Tmax lug kits change for T4, T5 and T8

Change notice

Future T4 configuration

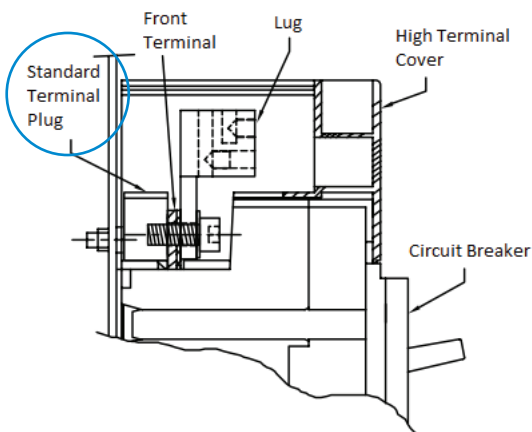
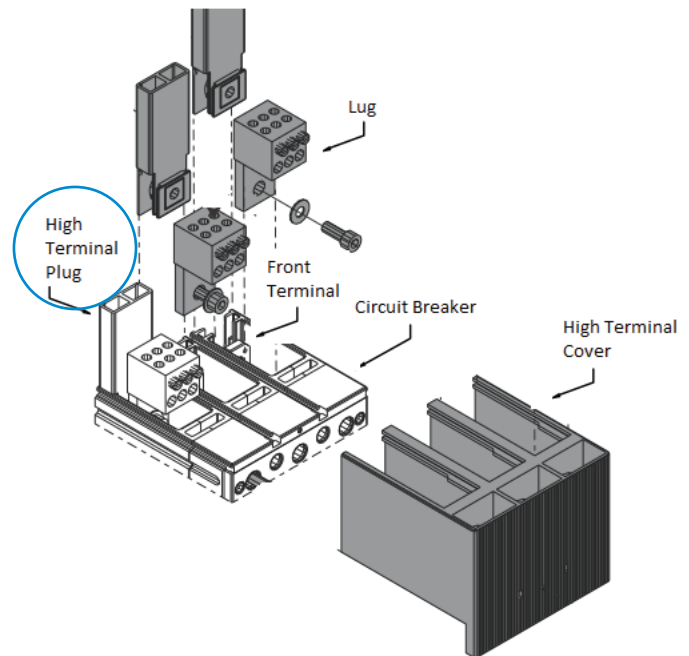
- KT4TN and KT4TN-4
- KT5TGD and KT5TGD-4
- K8TL and K8TM

Future T5 configuration

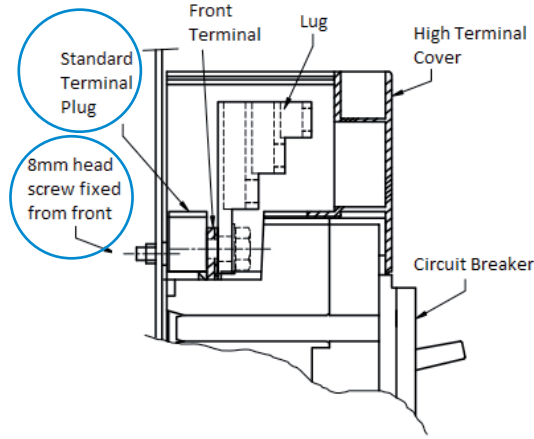
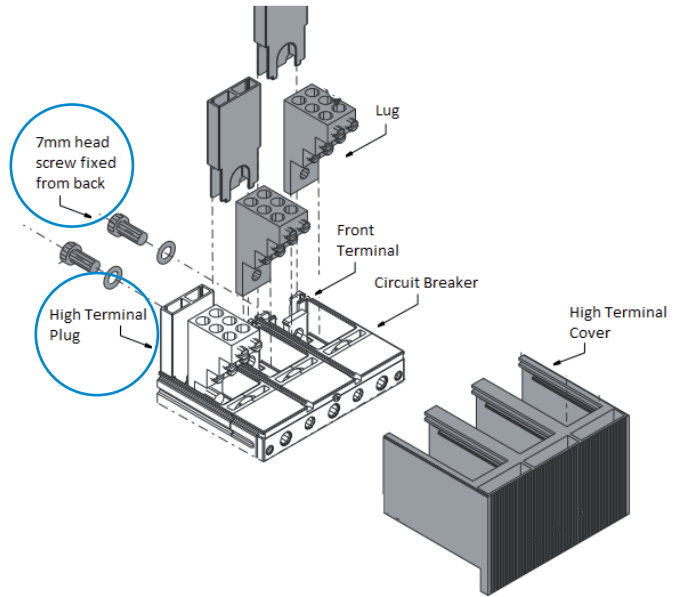
The T5 series multicable lug kits will now contain high terminal plugs as well. The high terminal plugs are to be used in place of the standard terminal plugs that are supplied with the circuit breaker and were previously used for this configuration. In addition, the screw used to fix the lug to the breaker will be changed from an 8mm head screw affixed from the front to a 7mm head screw affixed from the back.

Future T8 configuration

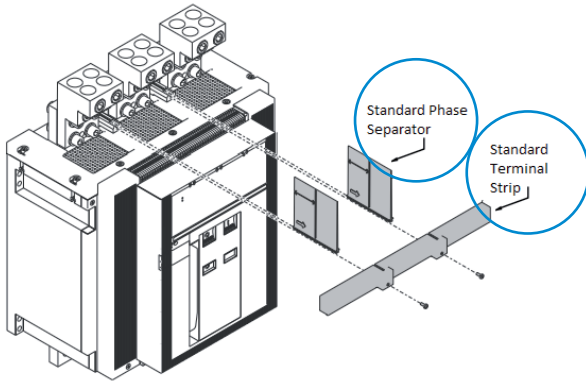
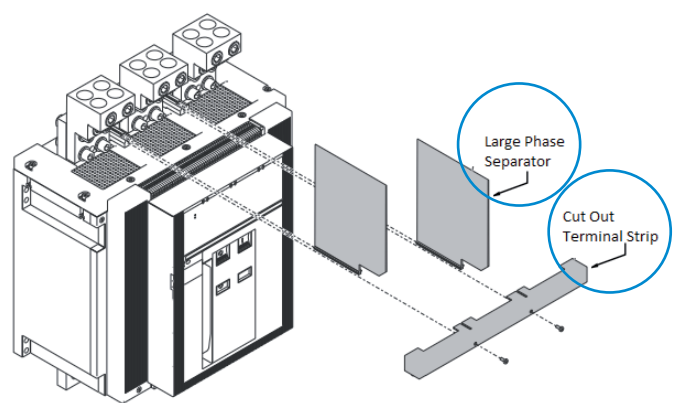
The T8 kits will now contain large phase separators and a cut out terminal strip. They are to be used in place of the standard phase separator and terminal strip that are supplied with the circuit breaker. The phase separators and terminal strip will be supplied with each kit, but are used only when installing the lugs on the top of the circuit breaker. Installation on the bottom of the breaker does not require the accessories.
